GFA AD 550

GFA AIRWORTHINESS DIRECTIVE

SUBJECT: Valve spring retainer.

REPLACEMENT OF VALVE SPRING RETAINER ON SINGLE VALVE SPRING CONFIGURATION OF ROTAX ENGINE TYPE 912 AND 914 (SERIES)

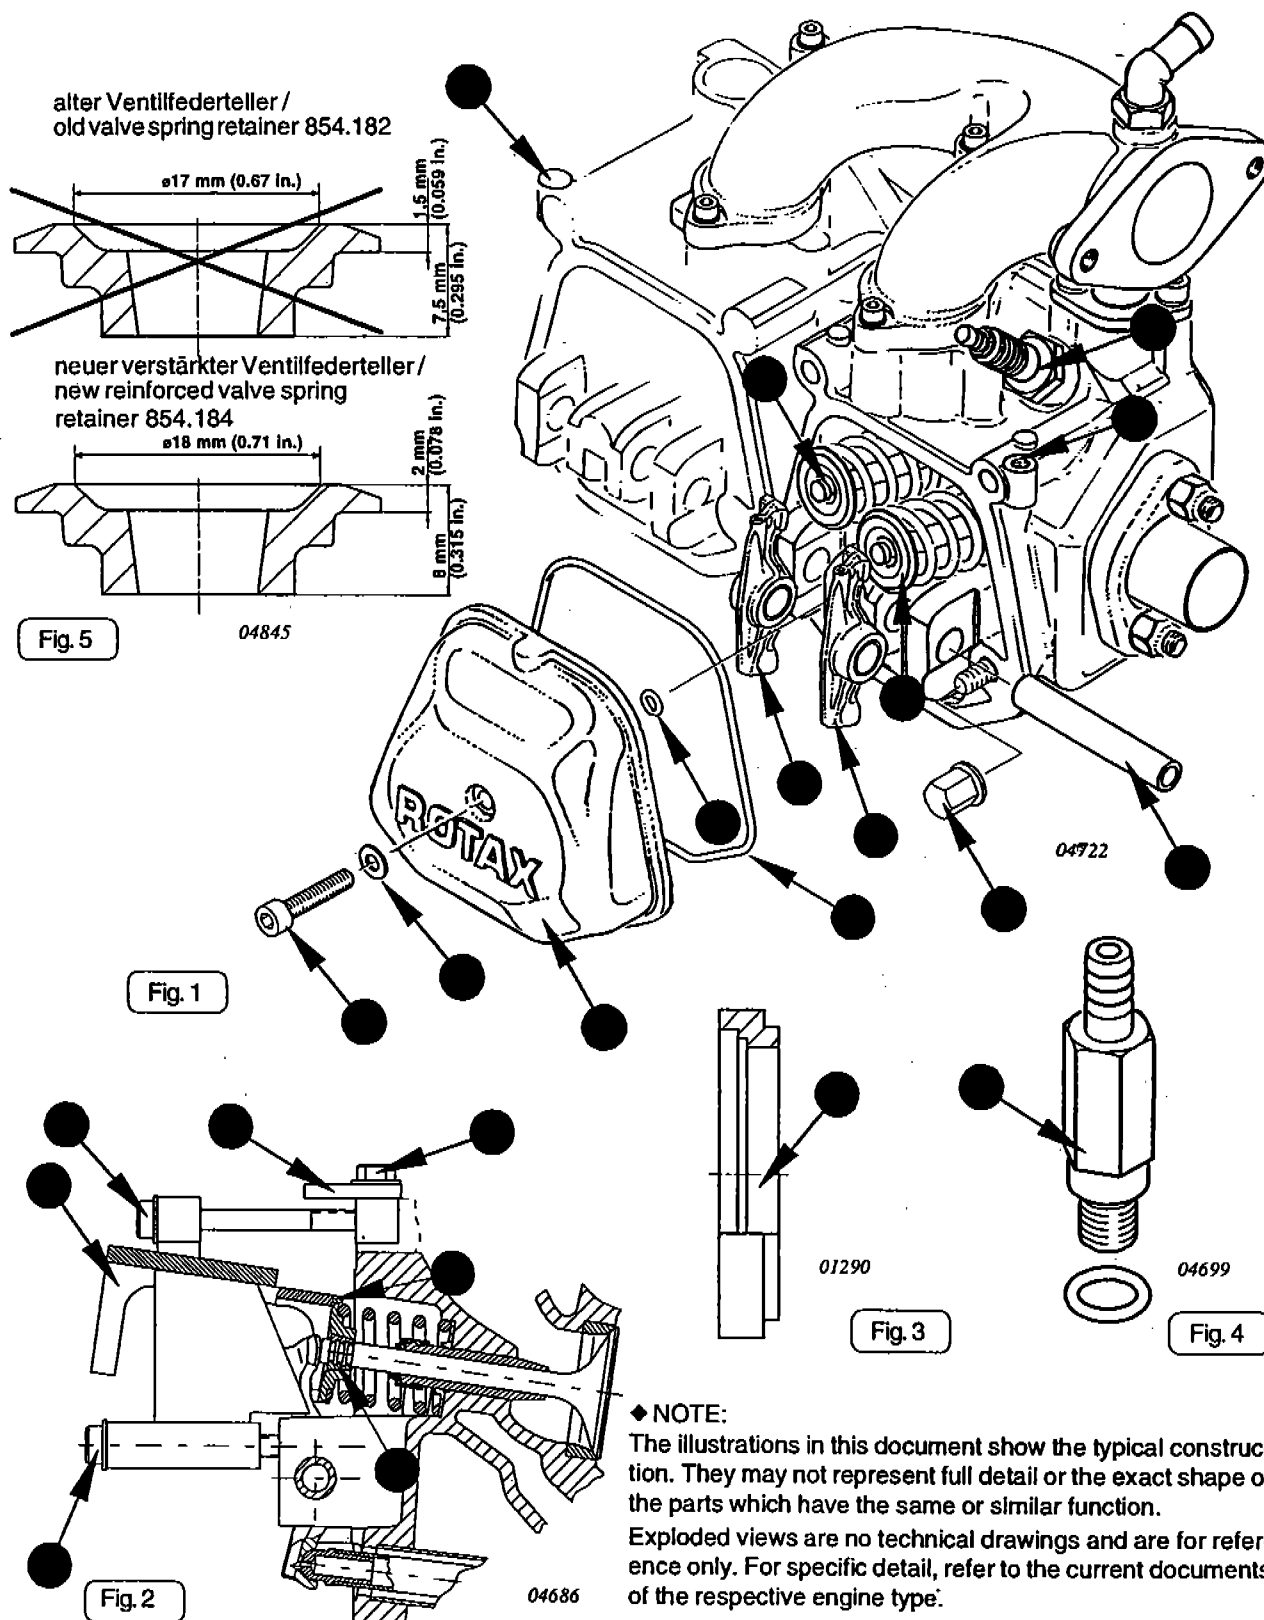
See pict. 1, 2, 3, 4 and 5.

- Place new reinforced valve spring retainer part no. 854.184 on the valve springs (see fig. 5).
- ◆ **NOTE:** To facilitate installation apply a bit of grease so that the valve spring retainer (3) will remain on the valve spring.
